CHAPTER 6[†]: CRITICALITY EVALUATION

This chapter documents the criticality evaluation of the HI-STORM 100 System for the storage of spent nuclear fuel in accordance with 10CFR72.124. The results of this evaluation demonstrate that the HI-STORM 100 System is consistent with the Standard Review Plan for Dry Cask Storage Systems, NUREG-1536, and thus, fulfills the following acceptance criteria:

FIGURE 6.4.16; LOCATIONS OF THE DAMAGED FUEL CONTAINERS
IN THE MPC-32.

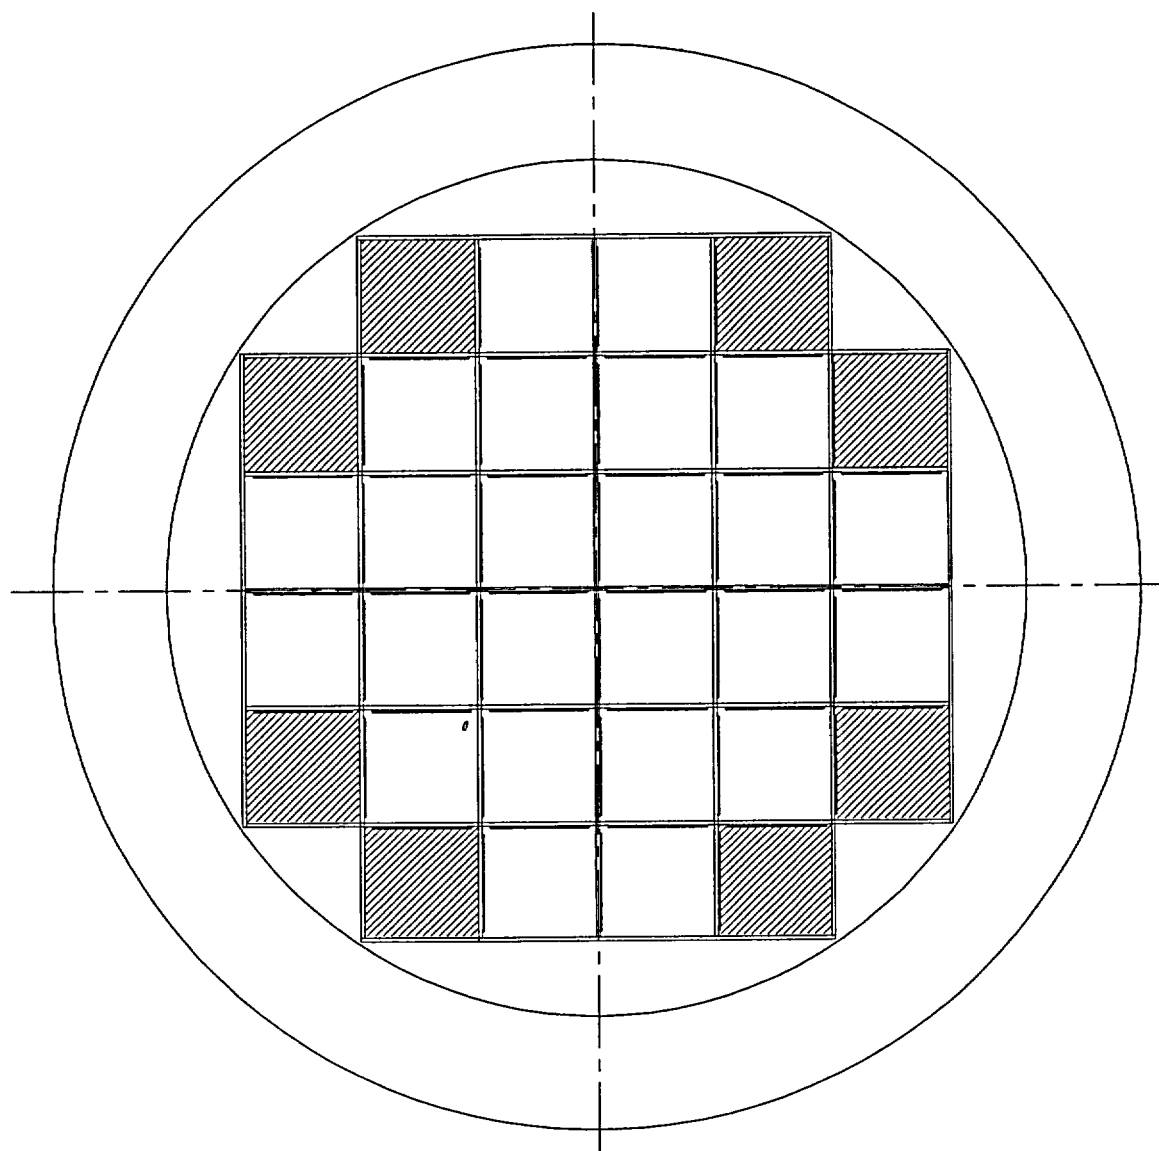
The MPC-32 allows the storage of up to eight DFCs with damaged fuel in the outer fuel basket cells shaded in Figure 6.4.16. The MPC-32F allows storage of up to eight DFCs with damaged fuel or fuel debris in these locations. For the MPC-32 and MPC-32F, additional cases are analyzed due to the high soluble boron level required for this basket:

FIGURE 6.4.17; DAMAGED FUEL/FUEL DERIS CALCULATION MODEL (PLANAR CROSS-SECTION) WITH BARE FUEL RODS IN THE MPC-32 BASKET
(SEE CHAPTER 1 FOR TRUE BASKET DIMENSIONS)

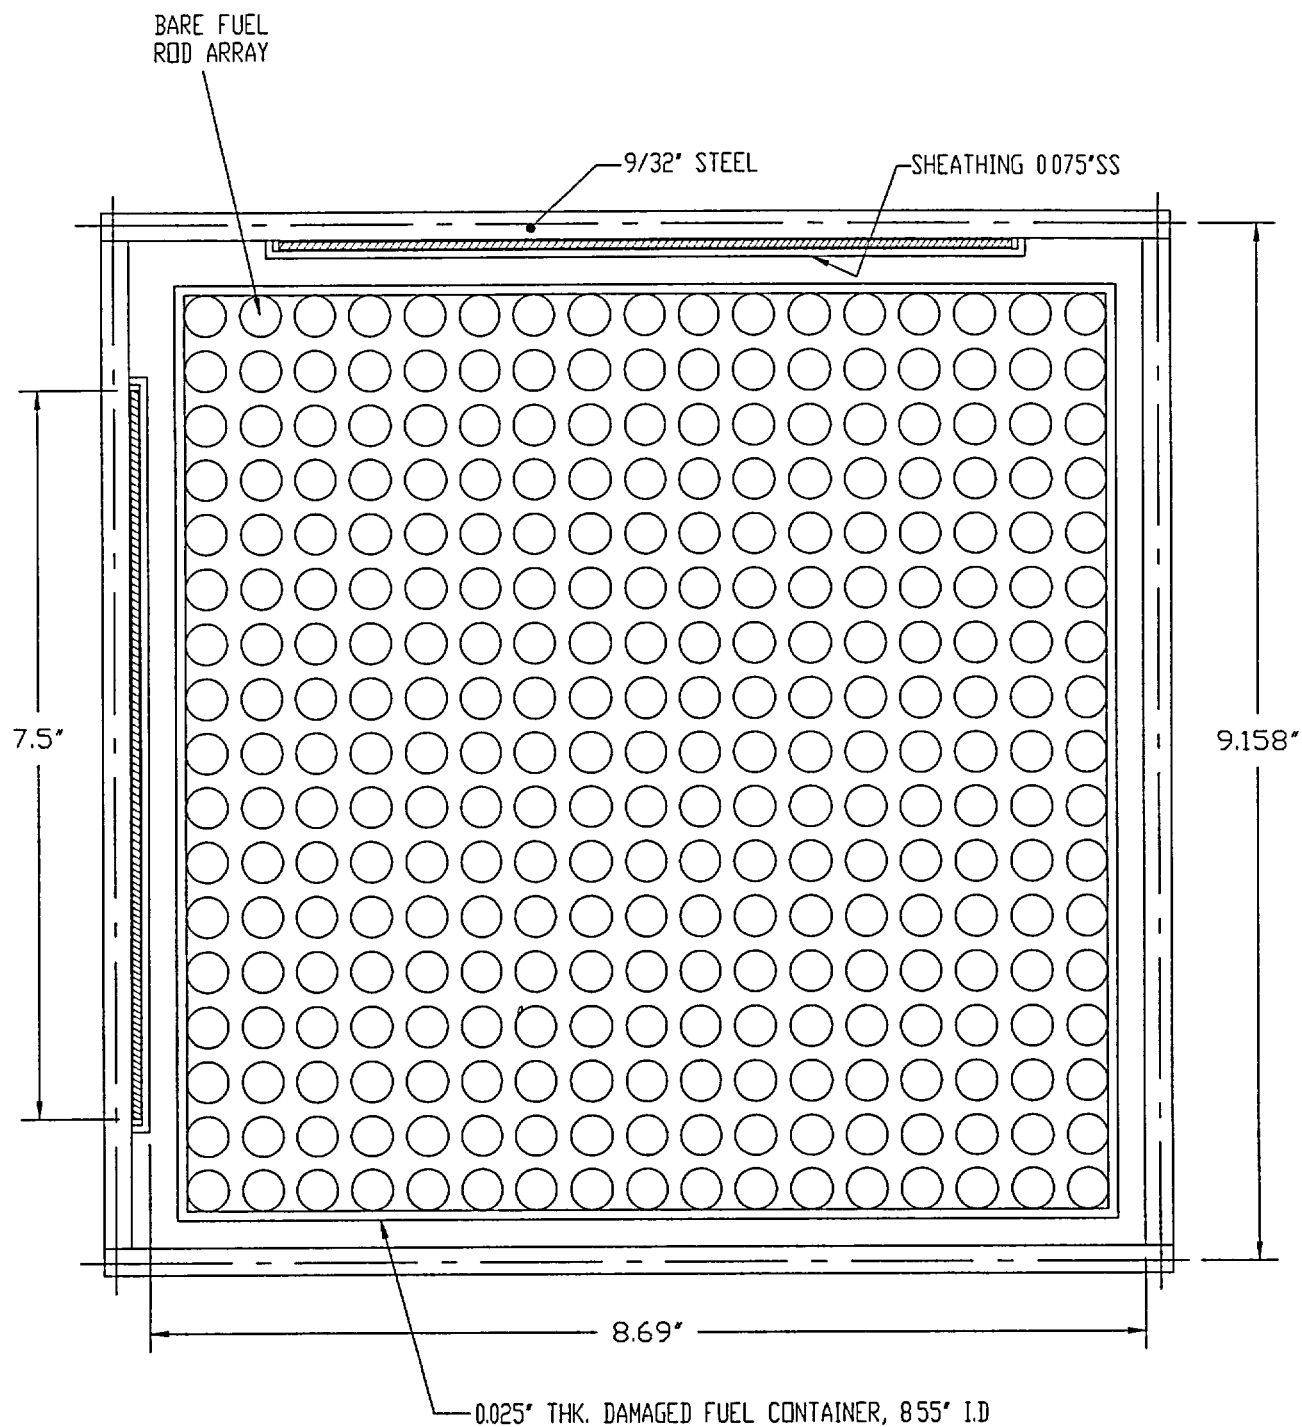
As an example of the damaged fuel model used in the analyses, Figure 6.4.17 shows the basket cell of an MPC-32 with a DFC containing a 17x17 array of bare fuel rods.
